### **Item 17 – CB/14/04277/FULL – R/O 1-5 Kingsbury Avenue, Dunstable.**

**Application No: CB/14/04277/FULL**

**Location: Land r/o 1-5 Kingsbury Avenue, Dunstable, LU5 4PU**

**Proposal: Construction of two semi detached dwellings and a detached double garage**

Fig 5.67 Scheme B (Unacceptable)

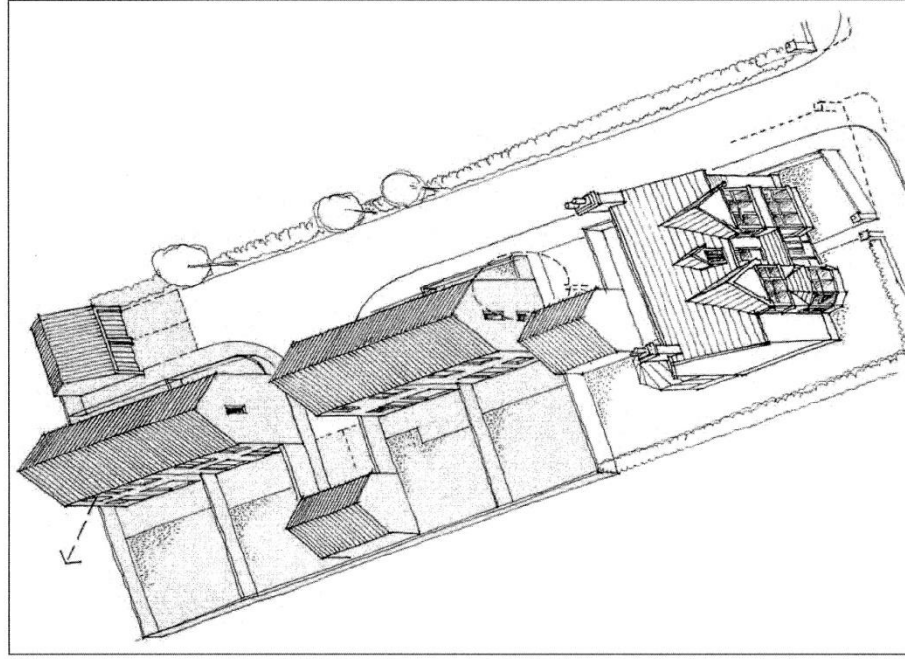
- 4) Please see the Unacceptable Schemes A and B for Infill/Backland developments highlighted in the Central Bedfordshire Design Guide Supplement 5 Pages 39 and 40 – a scanned copy is included at the end of this letter. A number of the design features deemed unacceptable are included in the plans for this site, including a road and parking dominated scheme, no regard to the enclosed and green character of the site, proximity of the two storey walls almost on the boundary creating overlooking and intrusive effect (with the acknowledgement in the Guide that this is a consideration even beyond the conventional minimum of 21 metres).
